SUBJECT: SAFETY RECALL OF CERTAIN 2010 AND 2011 J & E MODEL COACHES WITH DOGA WINDSHIELD WIPER MOTORS

Ref.: **NHTSA # 11V-150**
TRANSPORT CANADA #TC 2011-094
MCI Service Bulletin 356

Service Bulletin No. 356

<i>MODEL</i> E / J Series Coaches	<i>TYPE</i> Field Change Program	<i>SECTION/GROUP</i> 7-- Electrical	<i>DATE</i> Mar. 9, 2011
<i>SUBJECT</i> DOGA WINDSHIELD WIPER MOTOR WIRES			
<i>CONDITIONS</i>

Figure 1.

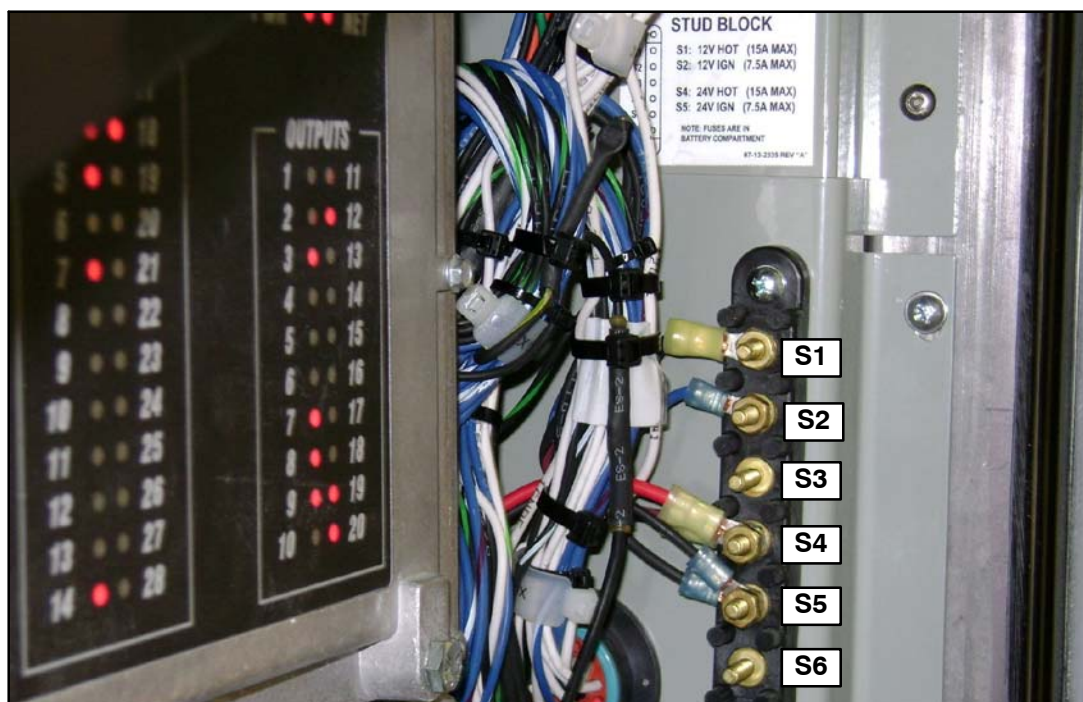
The wiring connections in the front junction box for the circuit powering the wiper system may be incorrect.

4. Locate the stud block on the compartment wall (refer to Figure 1).
5. Visually inspect to verify that the red wire, 1285A, is connected to stud block S4.
6. Visually inspect to verify that the black wire, 1244A, is connected to stud block S5.

If the wires are not installed properly, using a nut driver remove the red and black wires and re-connect them per Steps 5. and 6. Close the front service compartment door. Procedure complete.
